BHP Pilbara Strategic Assessment

**Jimblebar Significant
Amendment**

Validation Notice

31 January 2025

SCALE @ A4: 1:180,000 PREPARED: SPATIAL DATA FIGURE: S-9
DATE: 30/10/2024 REQUESTOR: ENV. APPROVALS NO: 1021/154F

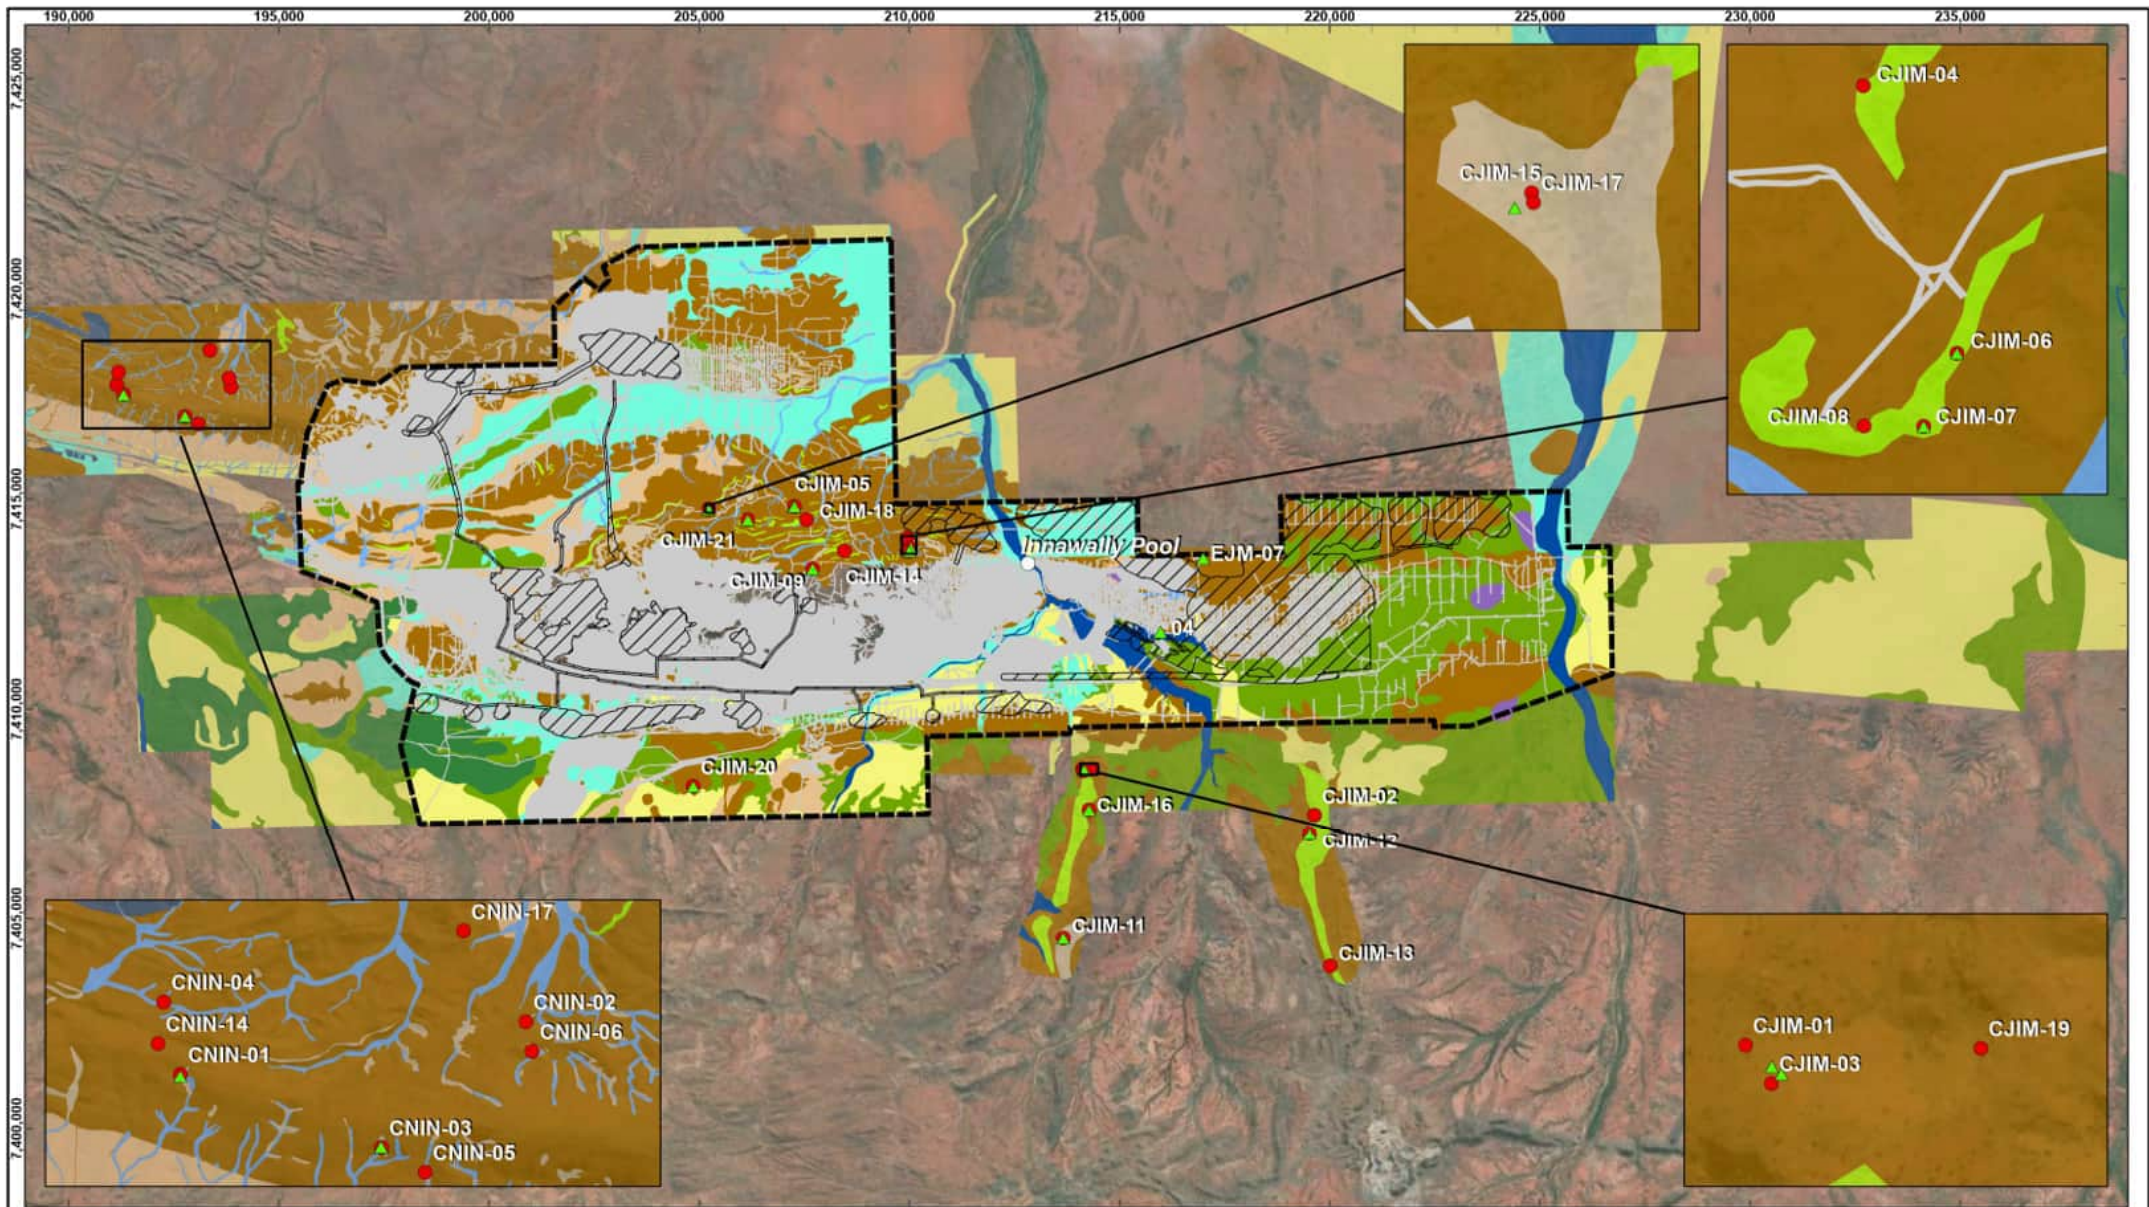
5.3.3.2 The department acknowledges that Figure 5-9 has been amended to show cave locations, cave identifiers (ID), enlarged areas, location of ghost bat records of all recorded Ghost Bat roosts within the Activity Area and surrounding the Activity Area that includes the proposed location of the project elements of the Activity as well as the habitat types. For future validation notices please include the cave category in the figure (as per Figure 4-6 in the published Jimblebar Optimisation Project Revised Validation Notice) so the reader is not required to cross-check the cave IDs with Tables 5-6 and 5-7 to determine the cave category classification	Noted.

5.3.3.3 Unintentional error: Figure 5-9 refers to the Proposed Development Envelope. Please amend to Activity Area.	Updated.
	5.3.3.4 We note BHP's response to the department's comments on the original draft validation notice that the Category 4 roost CJIM-22, included in the Draft Jimblebar Optimisation Project Revised Validation Notice, has been removed from this validation notice and the final Jimblebar Optimisation Project Revised Validation Notice published 24 August 2023, as a further survey determined it is a very shallow rocky overhang and is not a cave.	Noted.
